#### Amendment to Class B Airspace; Atlanta, GA

**ACTION:** Final rule.

## Modification of the Atlanta, GA Class B Airspace Area (Docket No. 08-AWA-5)

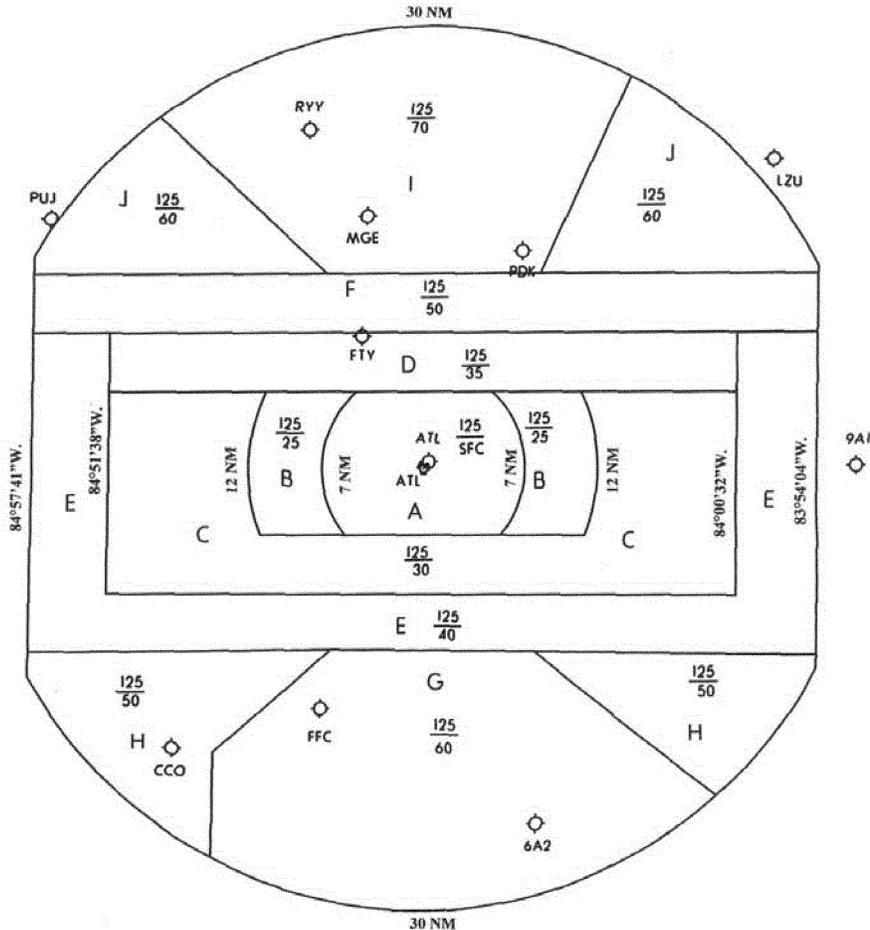
the Class B airspace design in that area. We determined that we can move the proposed north boundary of the 5000 foot area (Area F) to the south of PDK, and move the proposed boundary of the 6000 foot area (Area J—located northeast of PDK) to the east by 2 miles. This design change will lower the Class B floor over PDK from the current 8,000 feet to 7,000 feet instead of 5,000 feet as proposed in the NPRM. We believe that this accommodation will not compromise safety. The reduced size of the 5,000 foot area will still contain ATL departures operating beneath the arrivals as well as provide a higher Class B floor above PDK.

The descriptions of subareas F, I and J have been modified from that proposed in the NPRM. In light of public and Ad Hoc Committee inputs, the FAA reevaluated the Class B design in the vicinity of PDK and determined that the proposed 5,000-foot Class B floor airspace over PDK could be raised to 7,000 feet. This is accomplished by moving the northern boundary of Area F, and the southern boundary of Area I, to the south of PDK; and by moving the west boundary of the section of Area J (that lies northeast of PDK) to the east by two miles. The revised subarea descriptions are listed in the "Adoption of the Amendment" section, below. Additionally, a correction of one second of longitude is made to the Hartsfield-Jackson Atlanta International Airport reference point to reflect the latest FAA database values.

The FAA is amending Title 14 of the Code of Federal Regulations (14 CFR) part 71 to modify the Atlanta, GA, Class B airspace area. This action (depicted on the attached chart) reduces the overall lateral boundaries of the airspace and expands the vertical boundaries by lowering the floors of some subareas. These modifications are necessary to provide the additional Class B airspace needed to contain large turbine-powered aircraft operating to and from ATL. The modifications to the ATL Class B airspace area are summarized below. The following areas extend upward from the specified altitudes to 12,500 feet MSL:

The FAA has made changes relative to the NPRM by raising the floor of the proposed Class B in the vicinity of PDK from 5,000 feet to 7,000 feet. This may be relieving in that additional airspace will be available for GA operations relative to the proposal.
